Dringende veiligheidskennisgeving

Fout in Intellis™-gegevensvalidatiesysteem

Software-update van model A710 naar versie 1.3.130

Medtronic-referentienr: FA949

Afbelding 2: Prompt met systeemfout

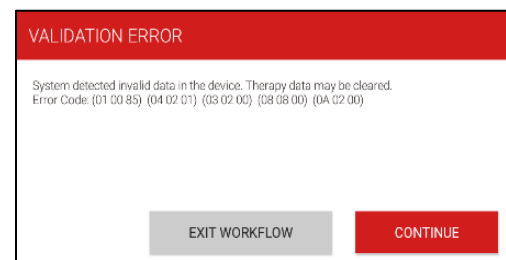
Medtronic heeft tussen januari 2020 en 24 november 2020 veertien (14) meldingen ontvangen van gebruikers die deze validatiefout (Afbeelding 1) gevolgd door een systeemfout (Afbeelding 2) ondervonden op het CT900 Artsenprogrammeerapparaat met de A710 Intellis-softwaretoepassing versie 1.3.80 met als vermelding dat de update voor het programmeren van de stimulator niet kon worden voltooid. Na onderzoek werd vastgesteld dat er sprake was van beschadiging binnen een bepaalde locatie van het stimulatorgeheugen en dat de A710 Intellis-softwaretoepassing versie 1.3.80 de beschadiging niet conform het ontwerp vrijgaf, resulterend in een systeemfout. Deze systeemfout treedt niet vaak op en de gerapporteerde frequentie waarmee de fout optreedt is minder dan 1 op 10.000.

Als, na het selecteren van de optie "**CONTINUE**" (Doorgaan), deze "**System Error**" (Systeemfout) (Afbelding 2) wordt weergegeven, neemt u contact op met uw Medtronic-vertegenwoordiger of met Medtronic Trading NL BV op 040-7117555 voor hulp met het downloaden van de meest recente A710 Intellis-softwaretoepassing v1.3.130. Breng na het downloaden van de meest recente Intellis-softwaretoepassing v1.3.130 de communicatie opnieuw tot stand en selecteer "**CONTINUE**" (Doorgaan) om dit probleem op te lossen.

Download de meest recente update van de A710 Intellis-softwaretoepassing, versie 1.3.130, naar het CT900 Artsenprogrammeerapparaat volgens de bijgevoegde instructies.

Afbeelding 1: Prompt van validatiefout

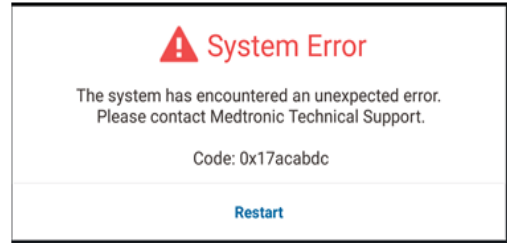
Als u wordt geconfronteerd met de VALIDATION ERROR (Validatiefout) (zoals geïllustreerd) met foutcode (01 00 85) (04 02 01) (03 02 00) (08 08 00) (0A 02 00) **voordat** u de meest recente A710 Intellis-softwaretoepassing v1.3.130 installeert, selecteert u de optie "**CONTINUE**" (Doorgaan). Als "**EXIT WORKFLOW**" (Workflow afsluiten) wordt geselecteerd, brengt u de communicatie opnieuw tot stand en selecteert u "**CONTINUE**" (Doorgaan) wanneer u wordt geconfronteerd met de VALIDATION ERROR (Validatiefout) (Afbeelding 1).
